**From:** Anthony McNevin [REDACTED]  
**Sent:** 30 March 2021 14:51  
**To:** Laura Gibbons <[Laura.Gibbons@arun.gov.uk](mailto:Laura.Gibbons@arun.gov.uk)>  
**Cc:** Raymond Cole <[Raymond.Cole@arun.gov.uk](mailto:Raymond.Cole@arun.gov.uk)>; Claire Potts <[Claire.Potts@arun.gov.uk](mailto:Claire.Potts@arun.gov.uk)>; Robin Shepherd [REDACTED] Jen Samuelson [REDACTED]; Robert Phelps [REDACTED]; Tarvit, John [REDACTED] Jon Regent [REDACTED] Craige Burden [REDACTED] Alan Brackley [REDACTED]  
**Subject:** Ford Airfield (Ref F/4/20/OUT) - Drainage Engineer Responses

Thank you for your latest comments regarding the surface water drainage strategy for the Ford Airfield development (Ref F/4/20/OUT) following the additional information and updated design provided in JNP Group Drainage Strategy Technical Note Ref C85228-JNP-XX-XX-RP-C-1000-P2 dated 10 February 2021.

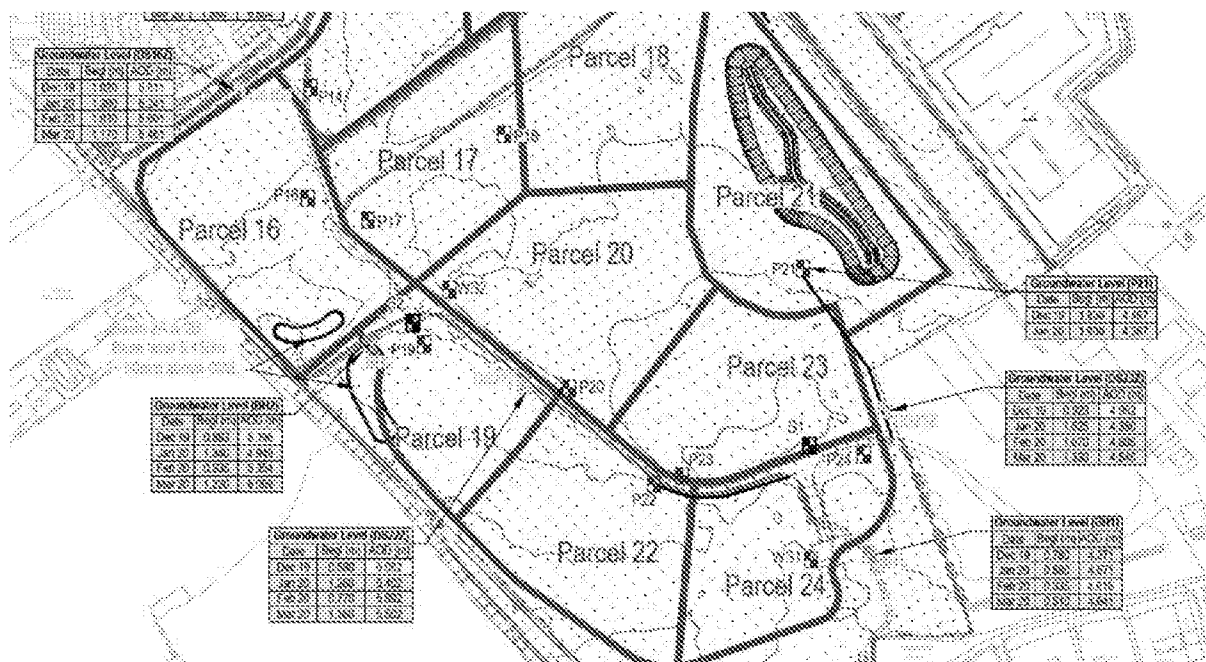
The proposals for attenuation and pumping of this area of the development do not comply with adopted WSCC policy for the management of surface water, specifically policy 3- mimic natural flows and drainage flow paths. No evidence has been submitted to show why compliance with this policy requirement cannot be achieved. The natural catchment appears to indicate this area should drain toward the watercourses under Yapton Road. We do not support drainage proposals which do not follow existing catchments or look to utilise pumping.

- 2.1 JNP Drawing C85228-SK130 summarises the direction the ground falls across the site. For the avoidance of doubt the natural ground surface profile in the north of the site falls to the northeast. In the south of the site the ground surface generally falls to the west/ south west.
- 2.2 JNP Drawing C85228-SK120 reviews the ground surface across the south of the site in more detail. It highlights that there are numerous depressions across the south of the site which collect surface water runoff, reducing the flow westwards
- 2.3 Groundwater monitoring, at relatively shallow depths, proves that groundwater flows northwards beneath the site.

2.4 The impact of the runways, access roads and existing surface water sewerage systems onsite which historically (for over 70 years) have captured surface water runoff and discharged it to the River Arun in the east should not be ignored.

2.5 The proposed drainage design strategy does discharge the westerly parts of the site to the watercourses under Yapton Road. The design mimics the current surface water runoff regime at the site.

2.6 The groundwater in the west of the site is extremely shallow. With reference to the monitoring results below it was less than 1.0m below ground level over the winter. The attenuation basin was located to Parcel 21 where groundwater is circa 1.9m below existing ground level over the winter period. This provides a more robust design for the south of the development.

2.7 The watercourse under Yapton Road / Horsemere Green Lane has a bed level of 3.03m AOD and a recorded water level of 4.00m AOD. The ground level at the western boundary of the site, nearest to the watercourse is circa 4.8m AOD. Groundwater has been recorded onsite less than 0.5m below the ground surface. Using open channels and basins in the west of the site is not feasible due to the risk of groundwater ingress. It is considered a pumping solution or significant ground raising would be required if the surface water runoff from all areas in the south of the development is directed to the Yapton Road watercourses.

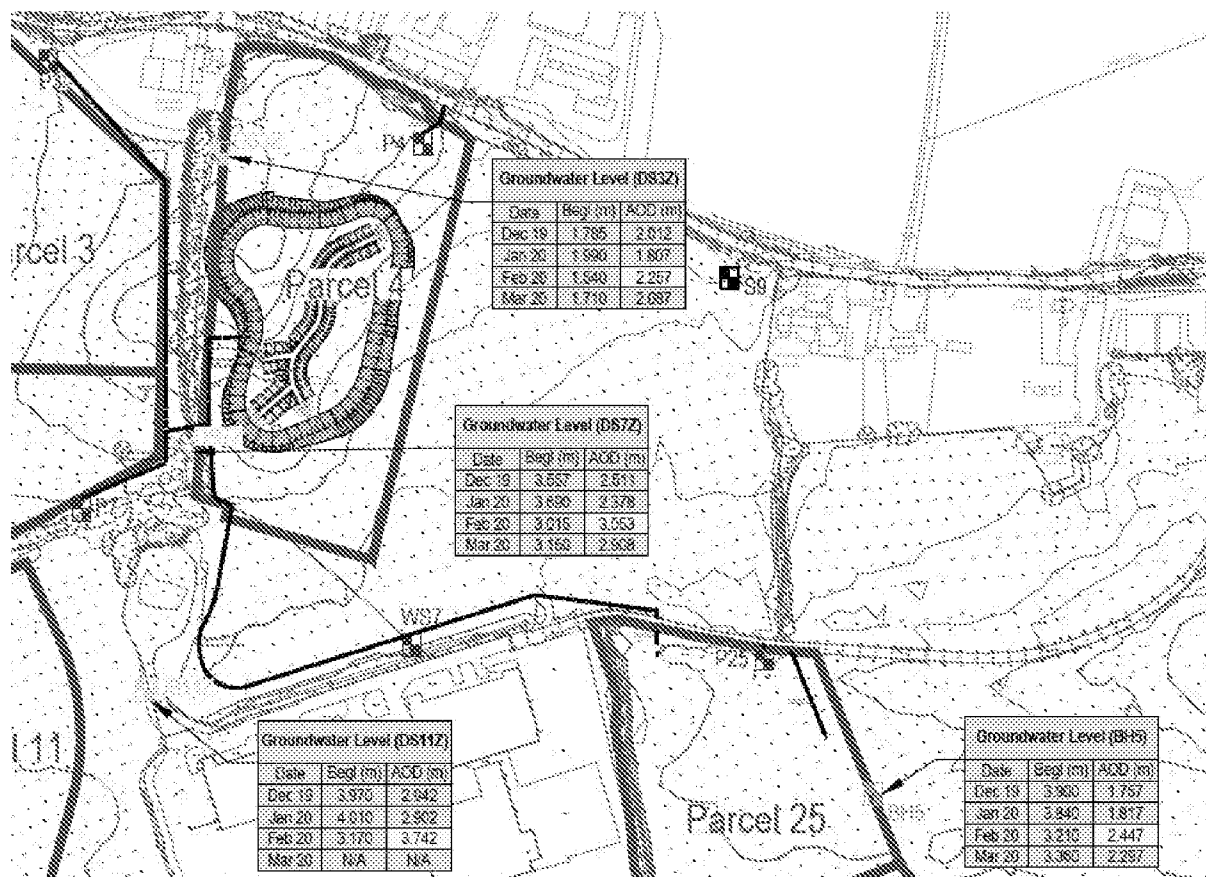
We note that the northern infiltration basin is proposed to have a base level of 2.45mAOD. There are two equidistant monitoring points from the proposed basin location, one of these recorded groundwater at 3.053m AOD. The proposed basin level therefore appears to be too low, without further evidence to the contrary. This will impact upon the upstream network, and may mean that a larger basin plan area is required. Groundwater monitoring at the location of proposed features will be required.

4.1 The groundwater monitoring of all wells across site show that groundwater flows northwards. In the north of the site the difference in water levels and the hydraulic gradient is significant. Water flows through the ground with the groundwater level deepening over short distances. The following extract from JNP Drawing C85228 D109E provided in the DSTN shows this.

4.2 Above ADC has highlighted the worst cast groundwater level in the monitoring well, to the south of the basin, is 3.050m AOD. The well to north recorded 2.257m AOD. The base of the basin is specified as 2.450m AOD. This diagram was included in Section 7.5 of the DSTN which advised “ the proposed base level of 2.450m would reduce the risk of groundwater ingress into the basin based on the worst case winter results taken during a significantly wet period”.

4.3 Due to the flow of groundwater through the underlying strata it does not appear that groundwater will pond in the basin. The groundwater levels recorded during the wettest winter period show groundwater is not level and is not static.

4.4 Section 7.8 of the DSTN confirms that basin has a 670mm freeboard to the crest of basin. The nearest plot FFL is 600mm higher than the crest of the basin. If groundwater is present in the base of the basin there is significant additional attenuation capacity.

4.5 We do not recommend the base of the basin is raised as this will increase the level of the incoming sewer network and ground levels across the north of the site. This will impact on earthworks and increase the volume of imported fill. The proposed solution and base level of the basin is the more sustainable option.

| Drawing No. C85228-SK120 |                                               |

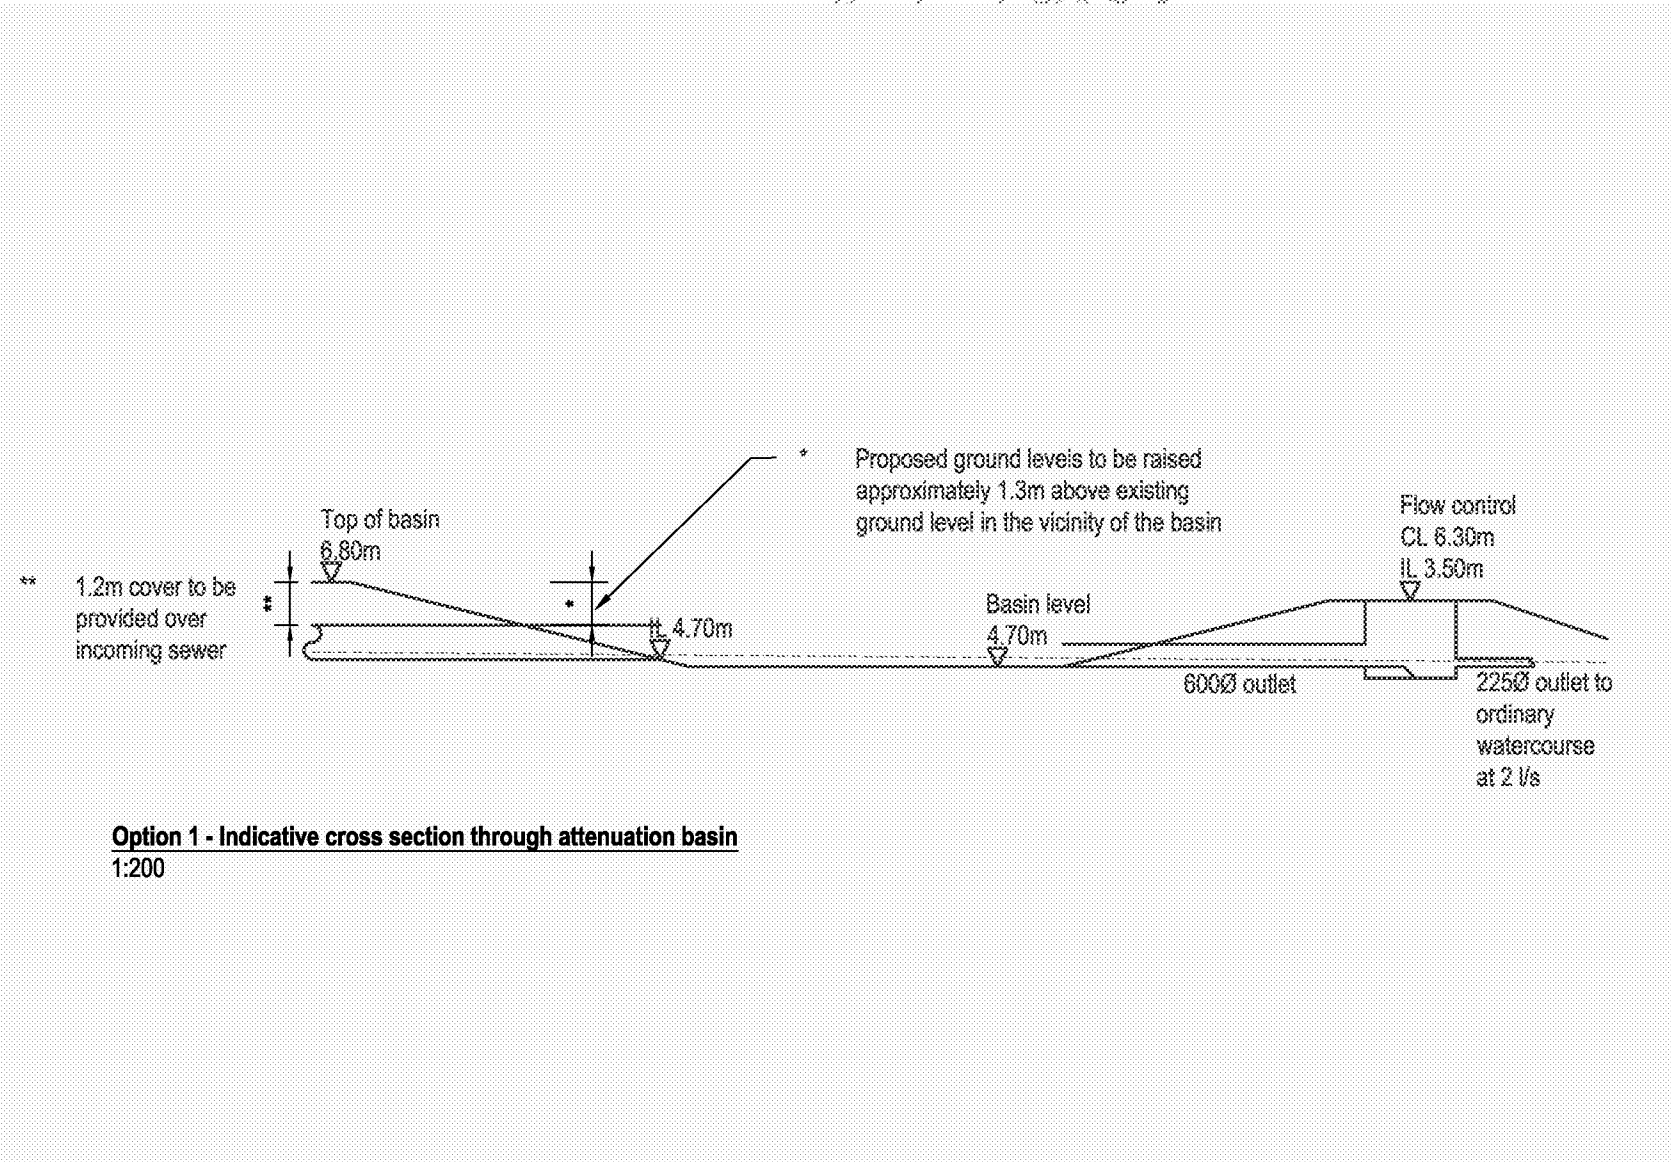
- 1.4 The FRA report included Sketch C85228 SK120. Sections 10.7.12 to 10.7.15 clarify that locating a basin or conveyance channels in the west of the site would:

- Require the west and south of the site to be raised in level to avoid groundwater ingress into the drainage features.
  - Require the site to be raised in level to allow a gravity connection to the watercourse at Yapton Road (with the outfall above existing water level in the watercourse)

- Would require significant earthworks and ground raising across the south of the development.

- 1.1 Locate attenuation basin in southwest corner
- 1.2 Approximate existing ground level = 5.500m
- 1.3 Interpolated design groundwater = 4.700m
- 1.4 Base of attenuation basin 4.700m
- 1.5 Ground levels across the entire southern parcel need to be raised between 1.00m to 2.00m (minimum). The earthworks required to achieve this is not feasible or sustainable

- 2.3 The base level of the basin is governed by the existing invert level of the sewer
- 2.4 The base of the basin will need to be 4.40m AOD. This is higher than the anticipated maximum groundwater level.

- 2.5 The outfall of the incoming gravity sewer network which serves the new development will need to be higher than the base of the basin. It is standard industry practice to set the outfall pipe 300mm higher than the base of the basin. Therefore, the invert level of the outfall sewer would be 4.70m AOD.

- 2.6 This is 0.60m higher than the outfall sewer required for a basin which will discharge by a pumping station - as shown on JNP drawing No. C85228-D100 and D101.

- 2.7 To enable a gravity solution the onsite sewer network will need to be constructed on average 0.5m higher than the sewerage system required for the pumping station solution. This will have a significant impact on the finish ground levels across the entire development and is not viable.
